Technical Letter Report on The General Electric PLEDGE Code for the Prediction of Environmentally Assisted Crack Growth Rates

Revised April 2, 2000

Prepared by
W. J. Shack

Program Manager
M. McNeil
USNRC Office of Nuclear Reactor Research

Figure 2.
Comparison of CGRs predicted by PLEDGE with experimentally observed CGRs. The comparison is of little use in establishing the validity of PLEDGE because relatively few of the data are taken under conditions in which environmentally enhanced cracking is significant.

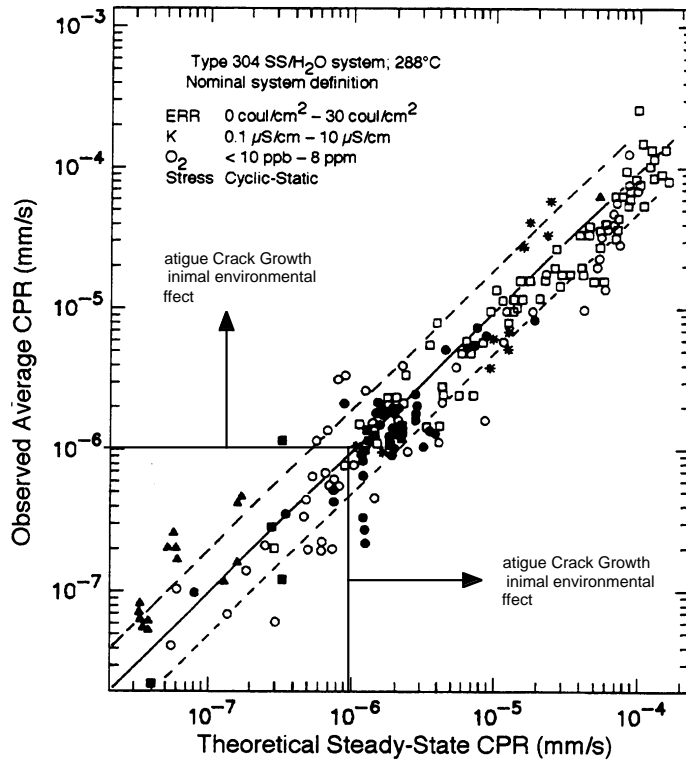
A comparison based on large set of data (340 pts) purportedly covering a wide range of environmental and material conditions is shown in Fig. 2. The figure was taken from Ref. 1, but also has appeared in many other papers. The only information available about the data is that shown in the graph. However, even if these data were to be documented, it is very unlikely that they would provide an adequate benchmark to demonstrate the adequacy of PLEDGE and estimate the uncertainties associated with PLEDGE predictions of SCC CGRs. Under typical BWR conditions, SCC CGRs are less than $3.5 \times 10^{-10}\text{ m/s}$ ($5 \times 10^{-5}\text{ in/h}$). This value has in fact been used as a conservative bound for NRC assessments. Only about 20 of the 340 data points in Fig. 2 appear to be obtained under conditions that give CGRs less than this value. There are about 20 more data with CGRs $<1 \times 10^{-9}\text{ m/s}$ where it could be argued that the environmentally induced cracking was at least some reasonable fraction of the mechanically driven CGR. The remaining ≈ 300 data points must have been obtained under cyclic loading conditions in which the scatter in the mechanically driven fatigue CGRs is at least as large as the environmentally induced CGRs (and for CGRs $>10^{-8}\text{ m/s}$ much larger). They are fatigue tests and would give similar results whether conducted in air or in water. Indeed PLEDGE itself predicts that under the cyclic loading conditions required to produce these high growth rates, there is little difference in the CGRs in air and in the environment.

Figure 5.
(a) Comparison of the predictions of the PLEDGE model with the Andresen data set; (b) Comparison of the predictions of the PLEDGE model with the ANL IGSCC data set; (c) Comparison of the predictions of the PLEDGE model with the BWRVIP data set

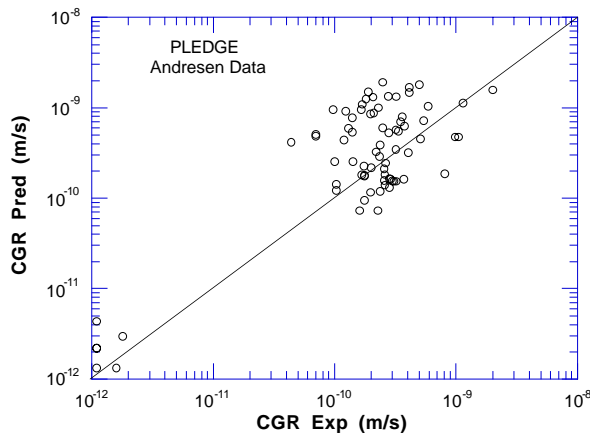
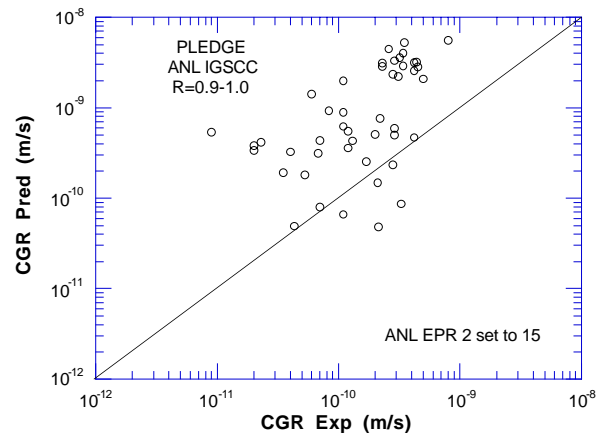
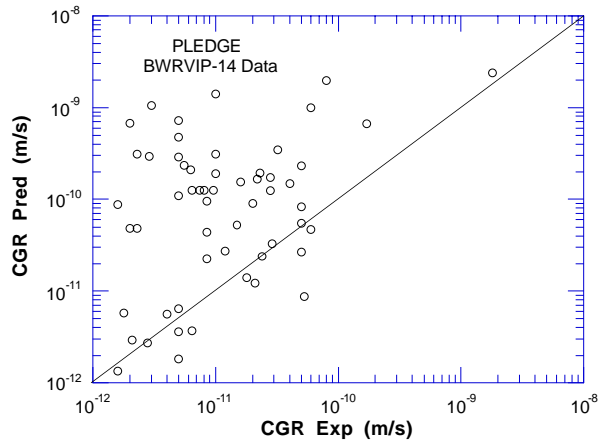
The PLEDGE predictions are compared with the Andresen, ANL IGSCC, and BWRVIP data bases in Fig. 5. Although there is considerable scatter in the results, in almost all cases the PLEDGE prediction is conservative. PLEDGE predictions are compared with ANL TGSCC in Fig. 6. In this case the appropriate EPR value is 0; and there is no particular bias to the predictions. The number of conservative predictions are about the same as the number of nonconservative predictions.

Figure 9 Comparison of BWRVIP data after screening by R. M. Horn with models (a) Conductivity $\leq 0.15 \mu\text{S/cm}$; (b) Conductivity $\leq 0.3 \mu\text{S/cm}$. The BWRVIP 95% confidence limit is very conservative for the screened data (scatter is reduced at low potentials).

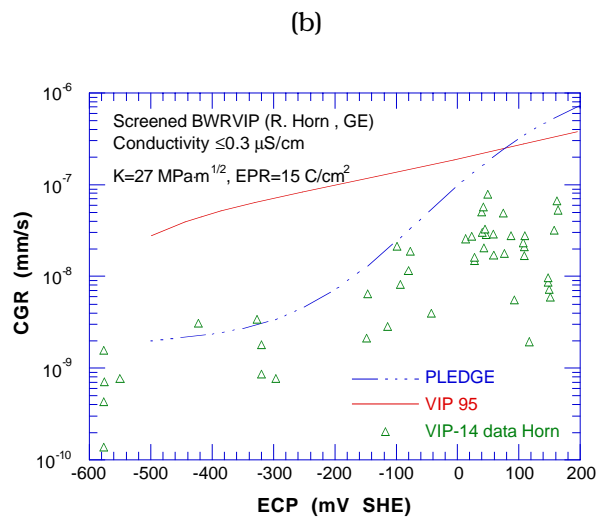
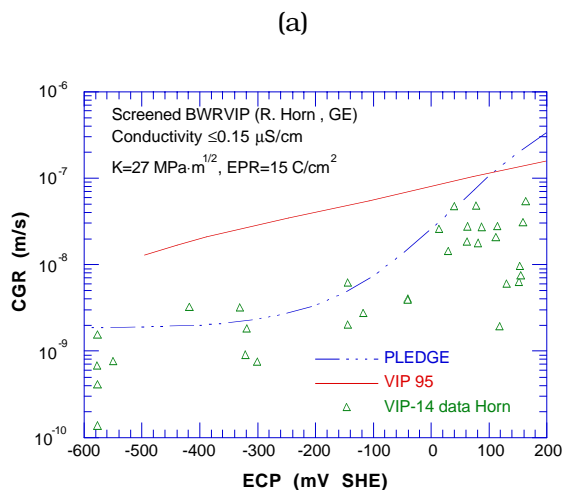
In Fig. 9 the predictions of PLEDGE and the BWRVIP model are compared with the BWRVIP-14 data base as screened by R. Horn of GE. The predictions of the BWRVIP model at low ECP are very conservative compared to those from PLEDGE and the screened data. PLEDGE predicts somewhat higher crack growth rates at high potentials.

Figure 10. (a) Comparison of the predictions of the PLEDGE model with ANL high DO data, data from Kawakubo et al.¹¹ and data used to develop the NRC Disposition curve; (b) Comparison of predictions of the BWRVIP 95 model modified to account for cyclic loading with the same data.

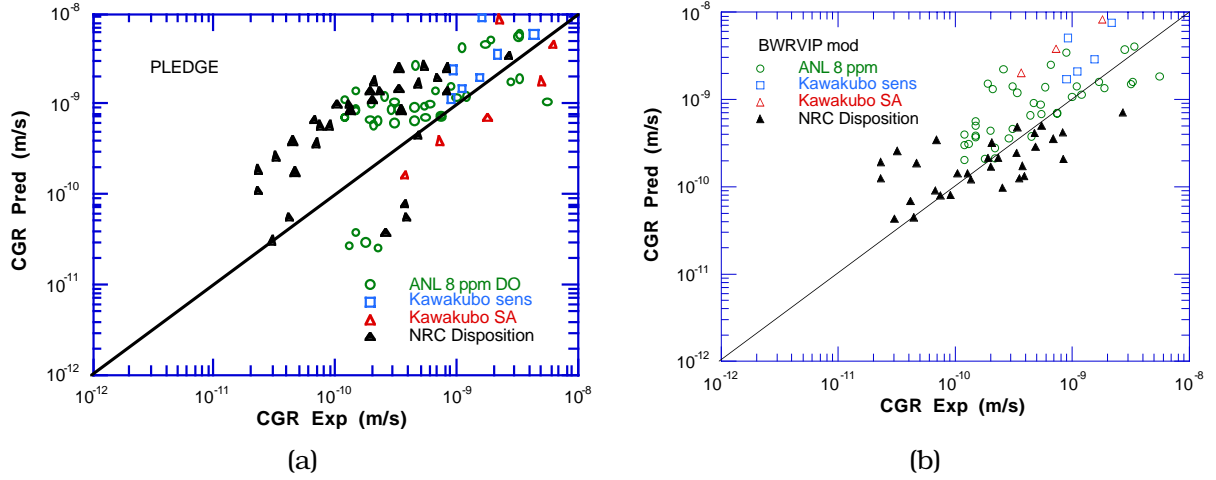
The predictions of the models with data for high dissolved oxygen levels from ANL and Refs. 11 and 12 are shown in Figs. 10. Both the PLEDGE and BWRVIP models are conservative in most cases. In Fig. 11 comparisons are shown with cyclic CGR data from ANL and Refs. 13-18. With an EPR value of 15 C/cm² the PLEDGE predictions are conservative for both sensitized and nonsensitized materials. When the EPR value is set to 0 as would be appropriate for nonsensitized materials, the results are no longer necessarily conservative.

Figure 19 Predicted effect of variation in conductivity on CGR for R=0.95 loading. Data shown are from a controlled test where conductivity was varied keeping all other variables constant

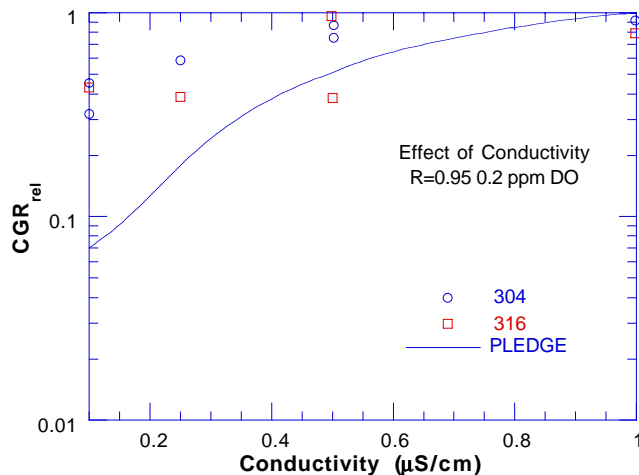
As noted from the examination of the databases, PLEDGE appears to predict a stronger dependence on conductivity than is observed. This is consistent with the results from a “controlled” experiment in which conductivity was systematically varied while keeping all other experimental parameters constant shown in Fig. 19. In application to operating reactors, the conductivity as defined by PLEDGE should be a conservative representation of the impurity effects. “Conductivity” is really used as a surrogate measure for harmful anions such as SO_4^{2-} and Cl^- ; other anions may be much more benign. PLEDGE assumes that the conductivity is due to the “worst-case” impurity, sulfate.

Figure 22 Predicted effect of variation in ECP on CGR for $R=0.95$ loading. Data shown are from a controlled test where ECP was varied keeping all other variables constant.

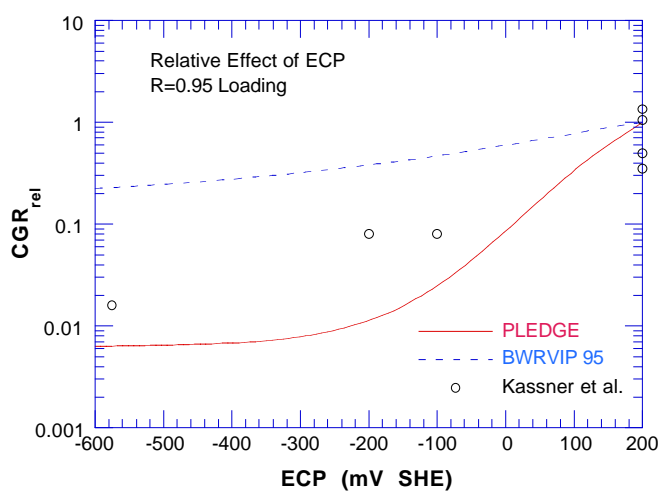
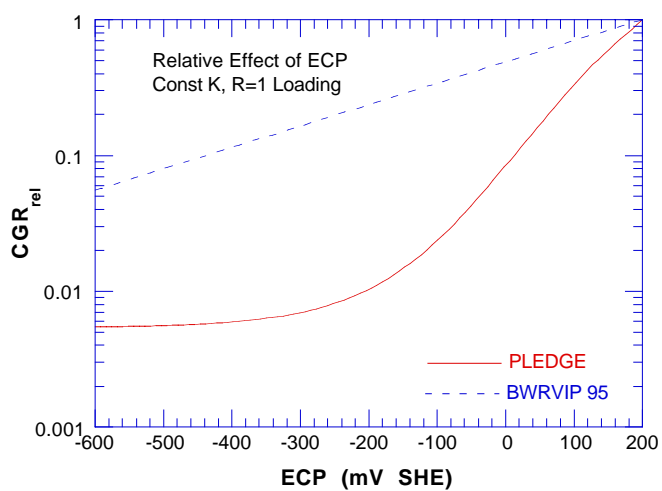
The predicted dependence of CGR on ECP is shown in Figs. 22 and 23. In this case the dependency is quite sensitive to the loading condition. Under $R=1$ loading the CGR essentially vanishes; under the $R=0.95$ loading, the mechanically driven CGR places a floor on how low the rate can go and so the relative change is smaller. The reductions predicted by PLEDGE are hard to verify experimentally, because the CGRs so low that they are extremely difficult to measure. The much more modest reductions predicted by the BWRVIP model are probably skewed by unavailability and scatter in CGRs at such low levels. Many of the ANL tests in hydrogen water chemistries are not reported as CGRs, simply because they were so low that it would take an inordinate amount of time to obtain a valid CGR. However, Ruther and Kassner carried out a series of tests on a thermally aged cast SS,²³ which showed a high susceptibility to environmentally assisted cracking, in which the tests were continued until the CGRs could be measured with some confidence. Their measurements are also shown in Fig. 22. They suggest that the BWRVIP model is very conservative at low ECPs, but that the PLEDGE model predicts the overall trends reasonably well. These results together with the results in Table 5 suggest that the PLEDGE model predicts the variation of the CGR with ECP fairly well overall, although it may overestimate somewhat the increases in CGR associated with increase in ECP above 140 mV.
